IN THE DRAWINGS

Please substitute the enclosed two replacement sheets for the original drawing sheets, containing figs. 1-7

REMARKS

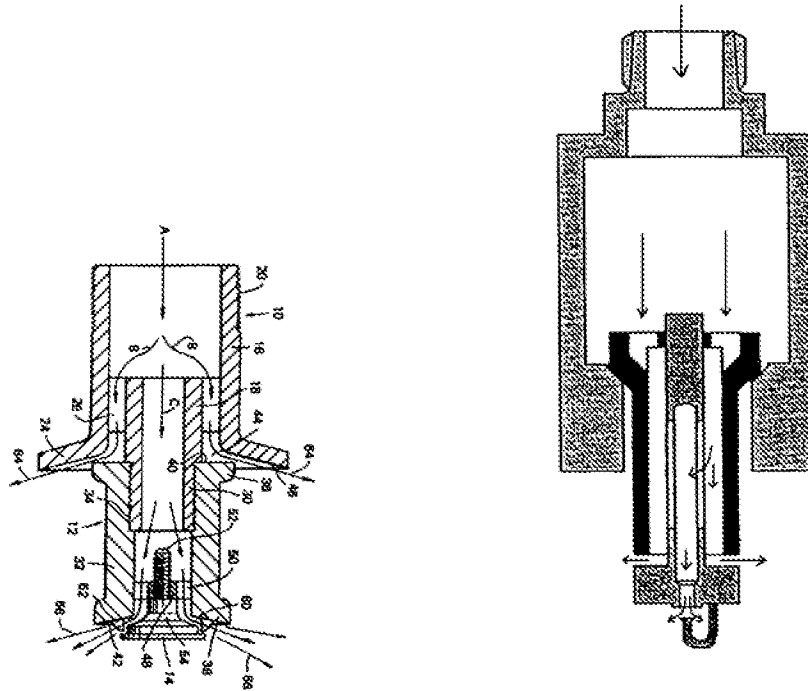
Claims 1 and 7 are not anticipated by Haisley. To begin, it is believed useful to review the operation of the applicants' invention. For reference, a version of Fig. 4, showing the liquid atomizer unit when in operation is depicted here.

In operation, the unit moves down into sealing engagement with the nozzle housing so that liquid entering the housing is directed through the holes or gaps located on the bottom 2 of the cup. All of the liquid then passes into the cavity of the cup where it is split, some passing to the gap 14 for discharge in a full 360 degree circle, another portion passing through the side holes or slots in the mandrel, into the center hole 10 for discharge from the central hole 17. Note that the hole 17 is unobstructed so a full cone of liquid is developed. After exiting the hole 17, the liquid is disbursed by a baffle 18 located in front of the hole 17.

Note that the mandrel is attached at the bottom 2 to the cup and there are no obstructions or attachments to the cup in the cavity.
